Access Compliance Report

Public Rights-of-Way

(Curb Ramps)

Intersection ID: 10025384	Main Street: E_9TH_ST	Cross Street: N/A	Location: SW
ADA ID: 1612C06BF63A	Ramp Type: Perp	Initial Pass/Fail: Fail	Overall Compliance: No
Severity Score: 8.75			
Codes/Mitigation Info/Possible Solution		Field Measurements/Component Compliance

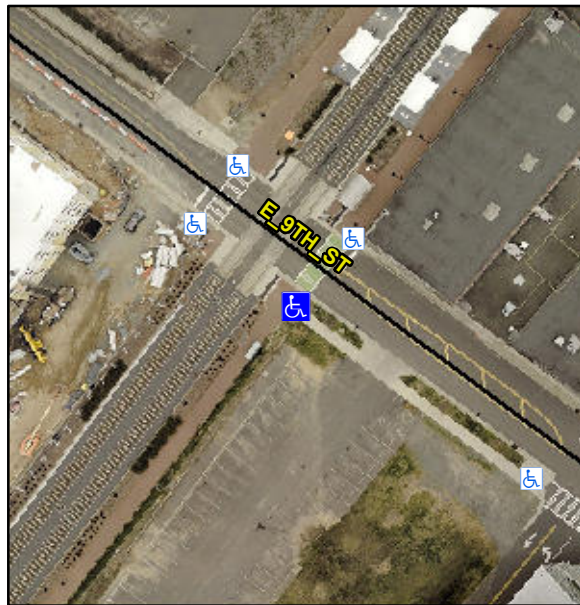
Not Found, R304.5.1

Compliance	Description	Data	Compliance	Description	Data
N/A	Ramp Length (in)	70.0	Yes	Ramp Slope (%)	6.3
No	Ramp Width (in)	47.0	Yes	Ramp XSlope (%)	0.4
N/A	Flare Type LT	N/A	N/A	Flare Type RT	N/A
N/A	Flare Slope LT (%)	N/A	N/A	Flare Slope RT (%)	N/A
N/A	Flare Traversable LT?	N/A	N/A	Flare Traversable RT?	N/A
N/A	Landing Length (in)	N/A	N/A	DWS Provided?	N/A
N/A	Landing Width (in)	N/A	N/A	DWS Contrast?	N/A
N/A	Landing Slope (%)	N/A	N/A	DWS Length (in)	N/A
N/A	Landing X Slope (%)	N/A	N/A	DWS Full Width?	N/A
N/A	Landing Curb? (Y/N)	N/A	N/A	DWS Offset (in)	N/A
N/A	Shared Landing?	N/A			
N/A	Gutter Ponding?	N/A	N/A	Gutter Slope (%)	N/A
N/A	Gutter Lip Ht (in)	N/A	N/A	Gutter X Slope (%)	N/A
N/A	Painted X Walk1?	Yes	N/A	Painted X Walk2?	N/A
	X Walk 1 Direction	To NE		X Walk 2 Direction	N/A
N/A	X Walk 1 Width (in)	111.0	N/A	X Walk 2 Width (in)	N/A
	X Walk 1 Slope (%)	0.2		X Walk 2 Slope (%)	N/A
	X Walk 1 X Slope (%)	1.0		X Walk 2 X Slope (%)	N/A

Remove & Replace Entire Ramp.
